GEORGIA POWER COMPANY
OGLETHORPE POWER CORPORATION
MUNICIPAL ELECTRIC AUTHORITY OF GEORGIA
CITY OF DALTON, GEORGIA
DOCKET NO. 50-366
EDWIN I. HATCH NUCLEAR PLANT, UNIT NO. 2
AMENDMENT TO FACILITY OPERATING LICENSE

Amendment No. 42
License No. NPF-5

ATTACHMENT TO LICENSE AMENDMENT NO. 42

Replace the following pages of the Appendix "A" Technical Specifications with the enclosed pages. The revised pages are identified by Amendment number and contain a vertical line indicating the area of change. The corresponding overleaf page is also provided to maintain document completeness.

FIGURE 3.4.1.1-1

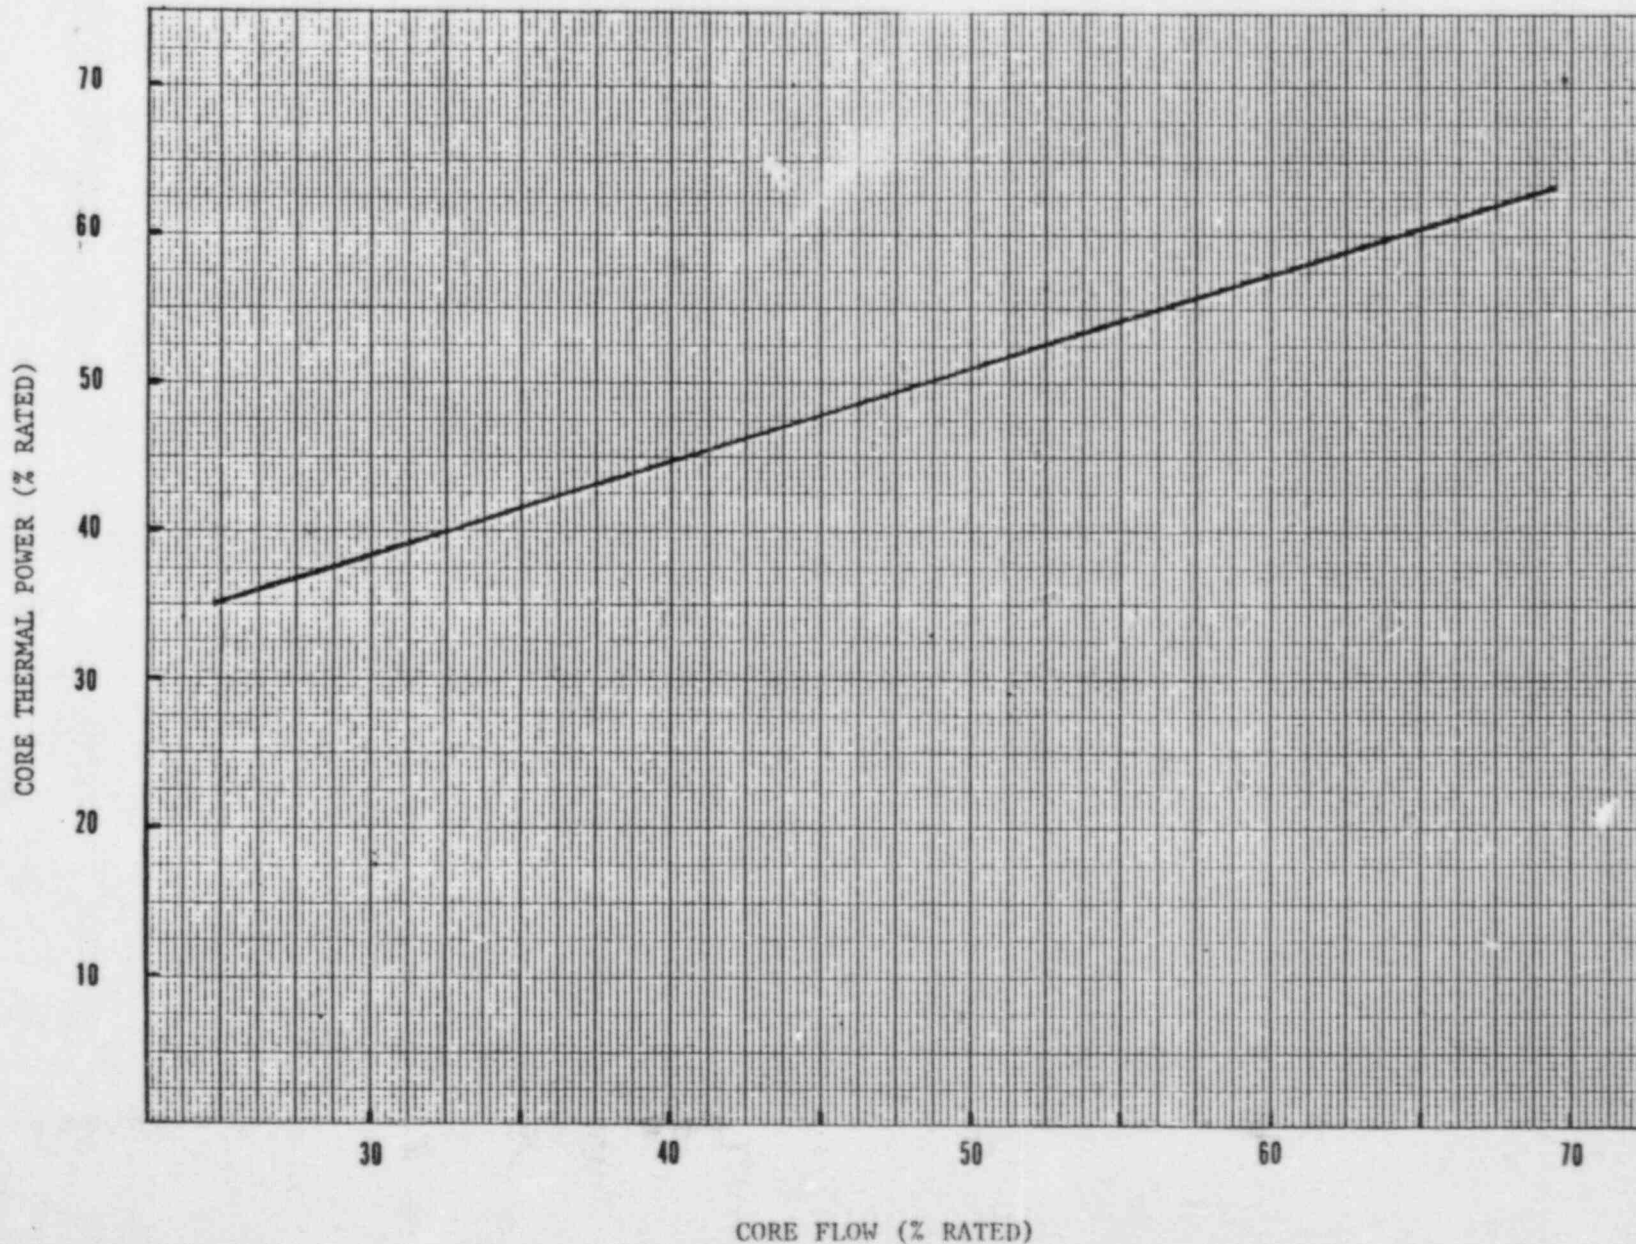
- a. With one recirculation loop not in operation, initiate action within 15 minutes and continue action to reduce reactor power to or below the limit specified in Figure 3.4.1.1-1 within 2 hours and restore both loops to operation within 12 hours or be in at least HOT SHUTDOWN within the next 12 hours.
- b. With no recirculation loops in operation, place the reactor mode switch in the Shutdown position.
